ADDENDUM NO. 03 to the plans and specifications for MACOMB COUNTY – COUNTY WAREHOUSE – F & O AND PURCHASING OFFICE RENOVATION, CLINTON TOWNSHIP, MI, Architect’s Project No. 242053, dated OCTOBER 31, 2024

Specification Sections: 01100, 07220, 08330, 08710, 10221, Revised Bid Form and Drawings G3.0, AD1.0, A1.0, A1.0A, A1.1, A1.2, A2.0, A3.0, A4.0, A4.1, A9.1, M1.10, M5.00, M6.00, E0.00, EP1.10, EL1.10 and E6.00 are being issued with this Addendum.

SUBJECT: RFB 29-24
QUESTIONS AND ANSWERS
MC WAREHOUSE – F&O AND PURCHASING RENOVATIONS

ENLARGED FLOOR FINISH PLAN
(PURCHASING)
SCALE: 1/8" = 1'-0"

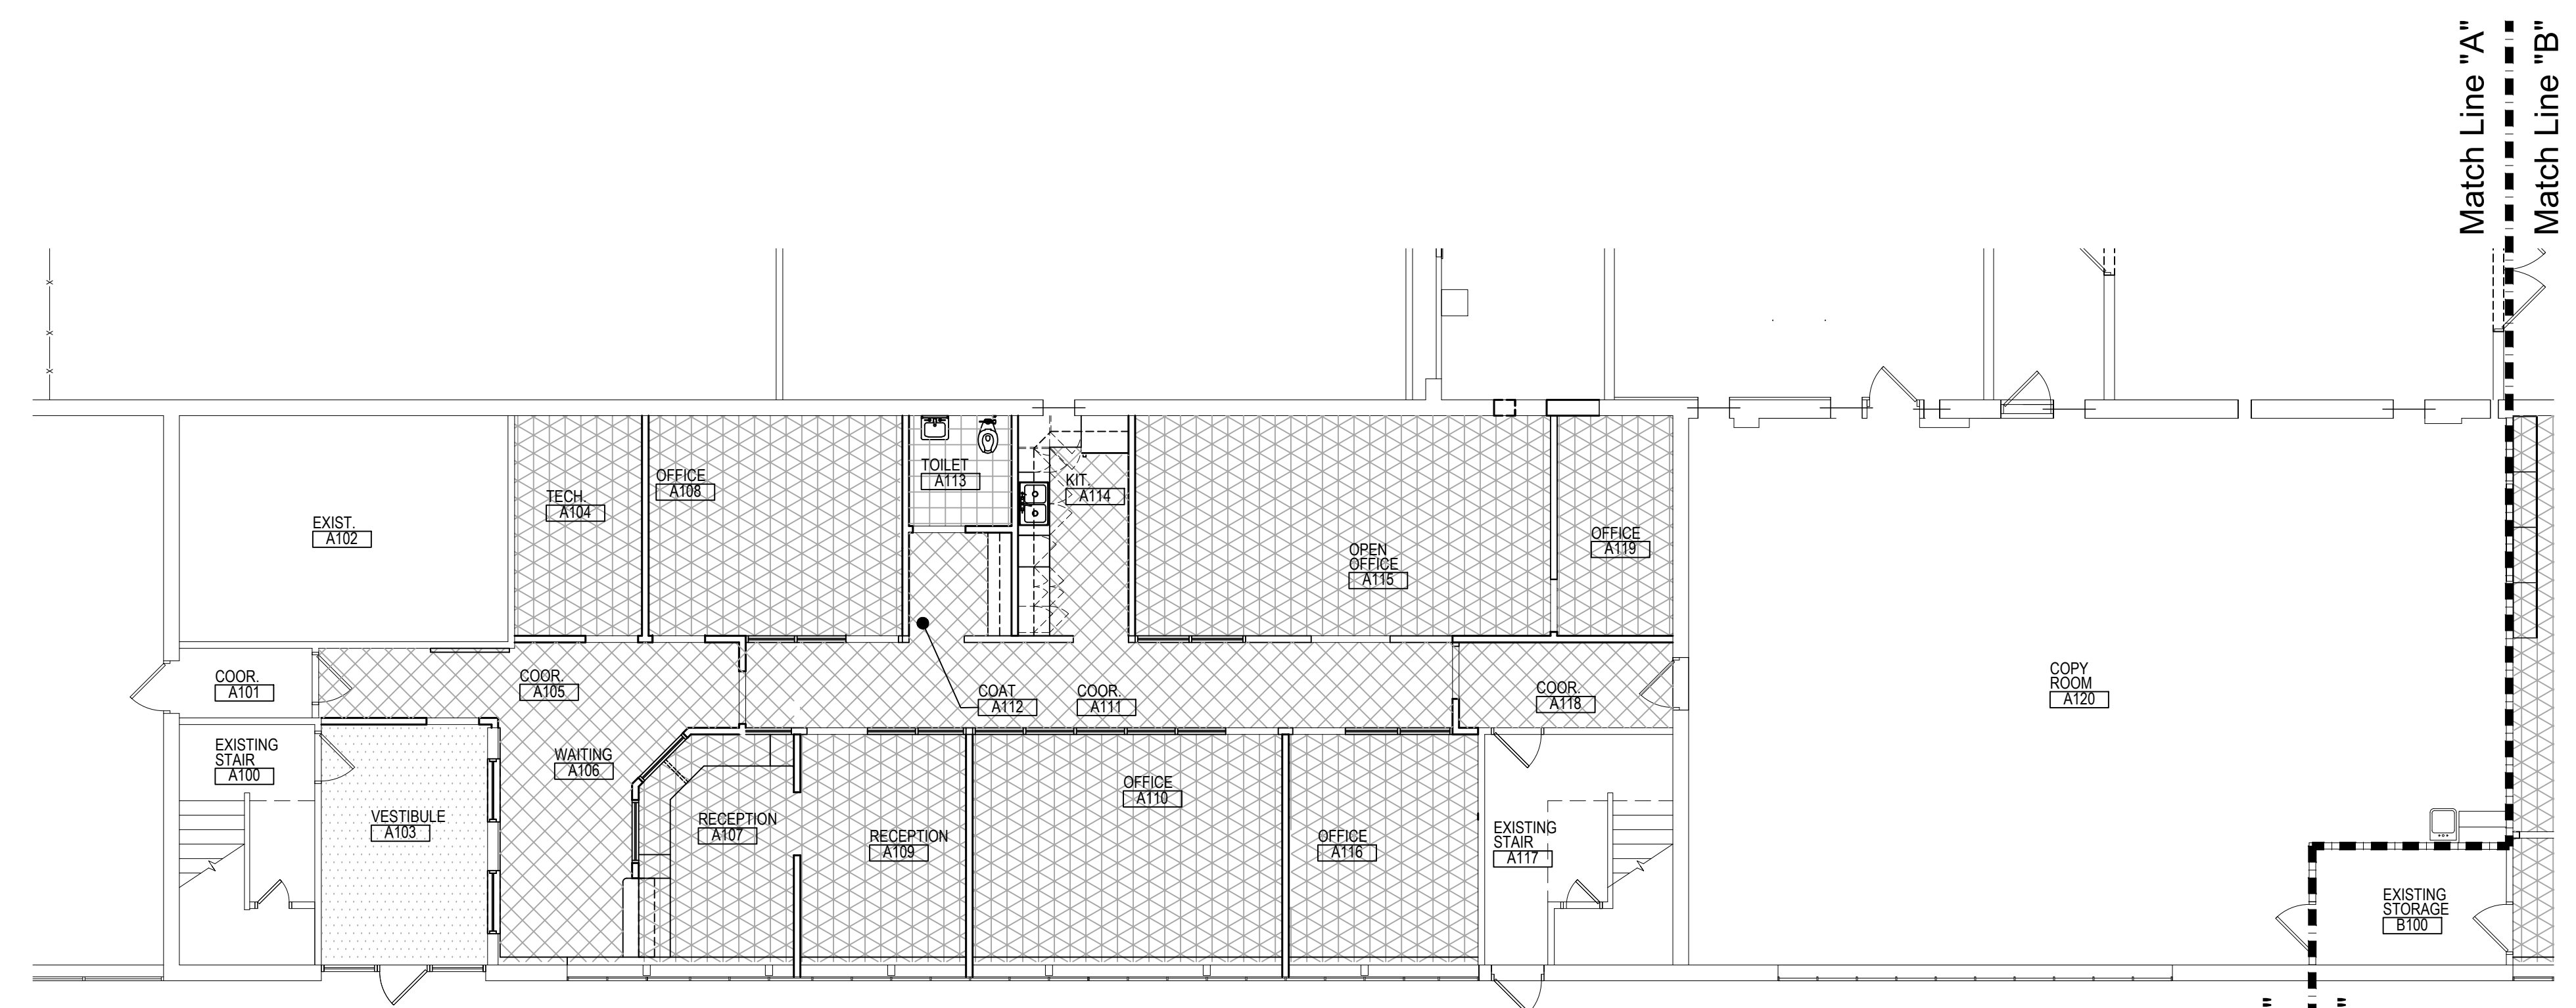
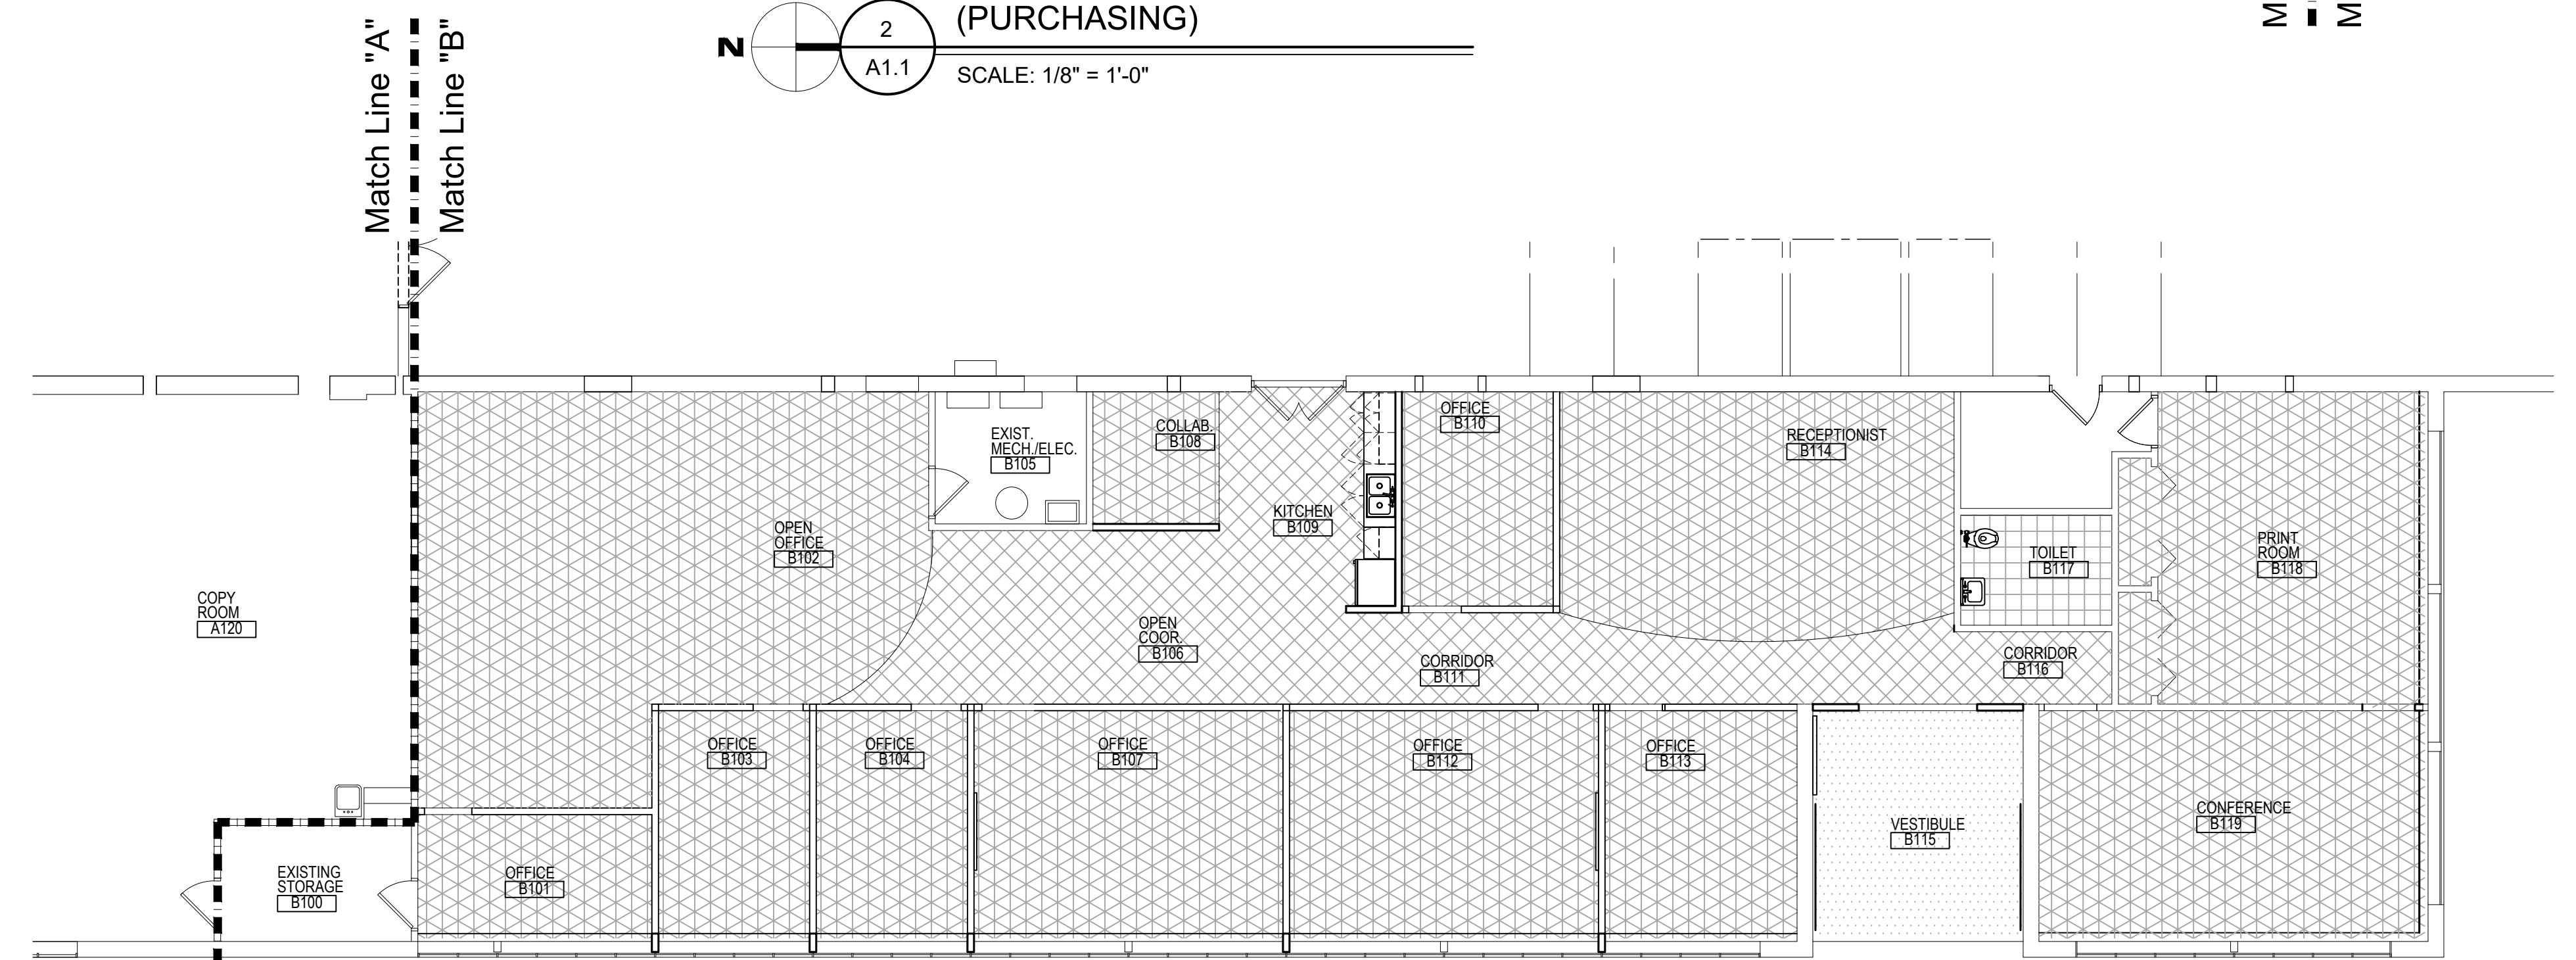
35. Per Drawing A1.2 Conference Room B119 & Print Room B 118 indicates new carpet, per drawing A9.1 Print Room B118 & Conference Room B119 indicates ETR, please clarify. – See addendum #3.

37. Per Drawing A1.2 Vestibule B115 indicates Walk Off Carpet, per Drawing A9.1 Vestibule B115 indicates Ceramic Tile, please clarify. – Walk off carpet is shown in both vestibules.

43. Per the plan set, Tech A104 Room Finish Schedule is LVT, yet the Floor Finish Plan is Carpet, please clarify. – See addendum #3.
44. Regarding the trapezoid shapes on the RCP, will they be mounted to the deck or be suspended, please clarify. – They are suspended with a system manufactured by the ceiling manufacturer. See detail 14 on sheet A1.1.

ENLARGED REFLECTED CEILING PLAN (PURCHASING)
SCALE: 1/8" = 1'-0"

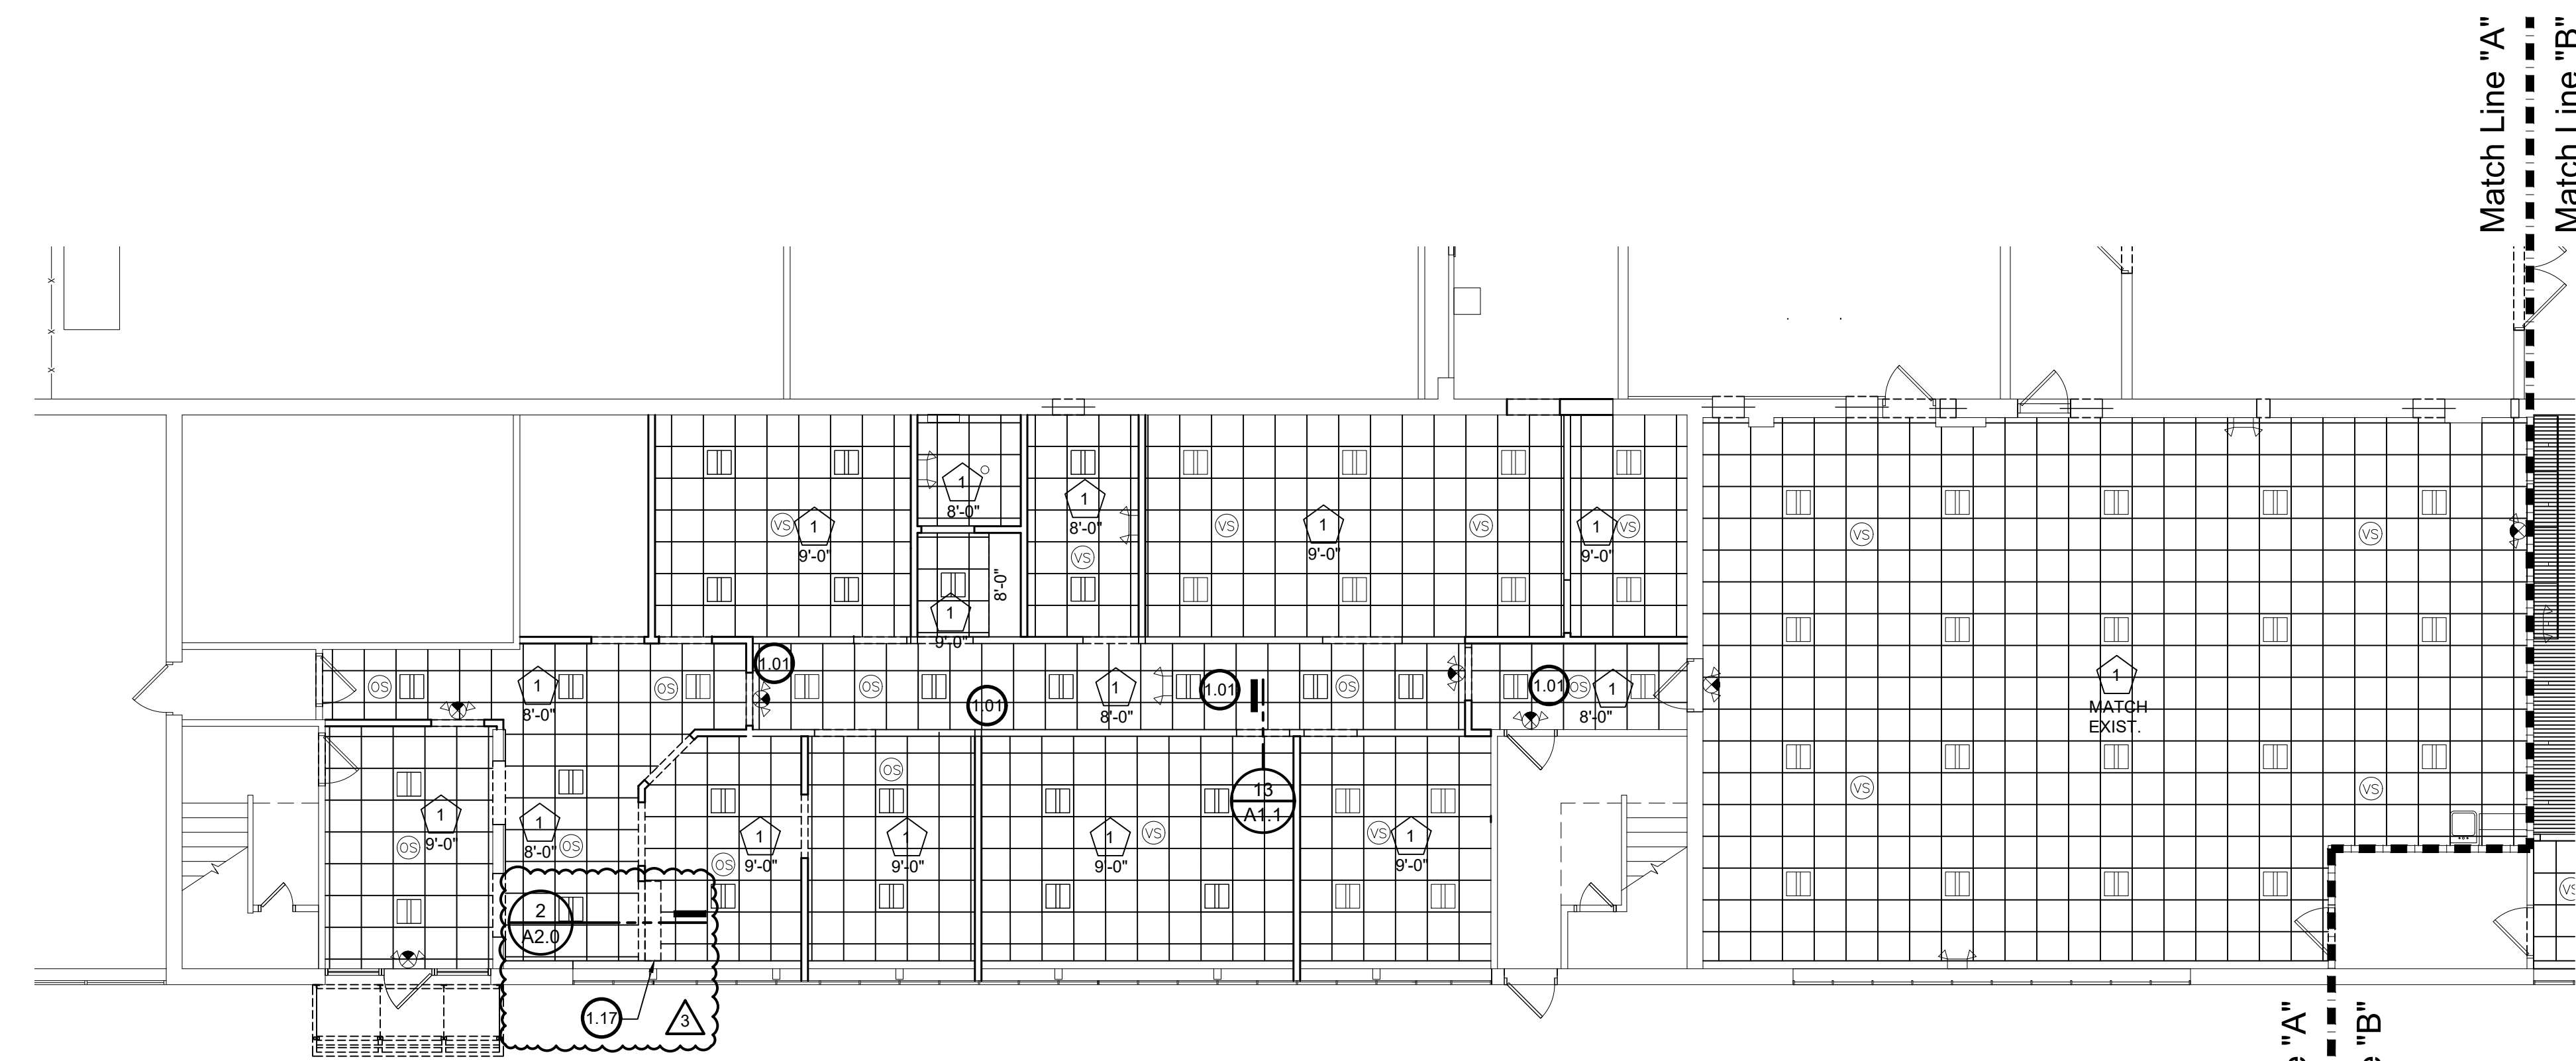
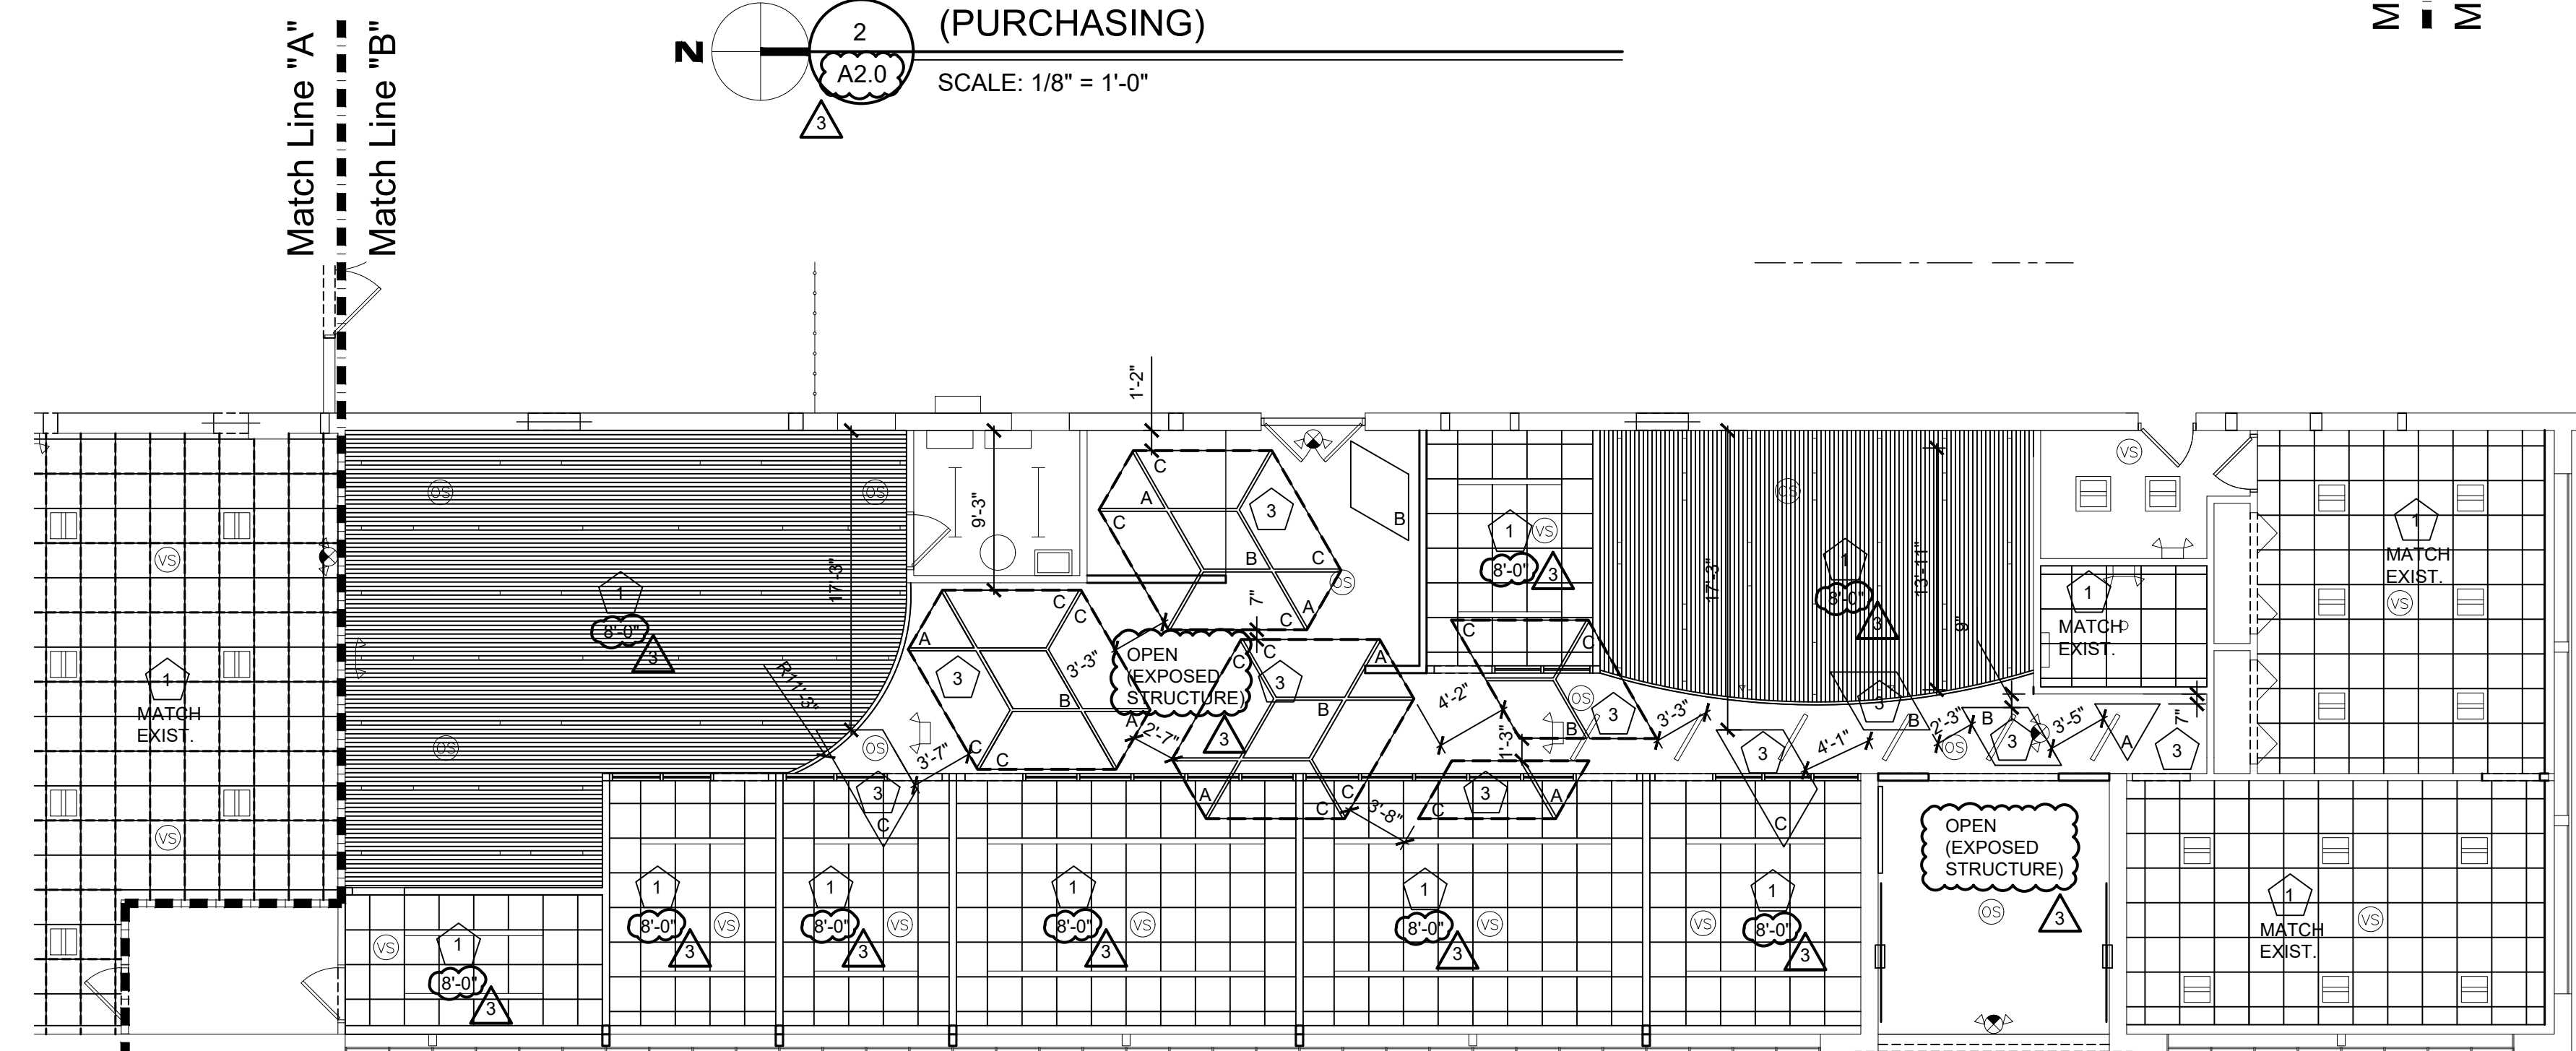
46. Per Drawings A1.1 and AD1.0, please clarify differences between wall type D1 and wall note 7. – See answer to question 26.
47. Per Drawing A2.0, please further clarify where the K13 is to be used. – See addendum #3.

NOTES:
1. IN ALL OPEN AREAS, (ENTIRE F&O AREA) PAINT ALL EXPOSED DECK WITH K13 INSULATION BETWEEN JOISTS AND AROUND STEEL. PAINT STRUCTURE, DUCTWORK, AND CONDUIT ETC. COMPLETE FOR A FINISHED PRODUCT.
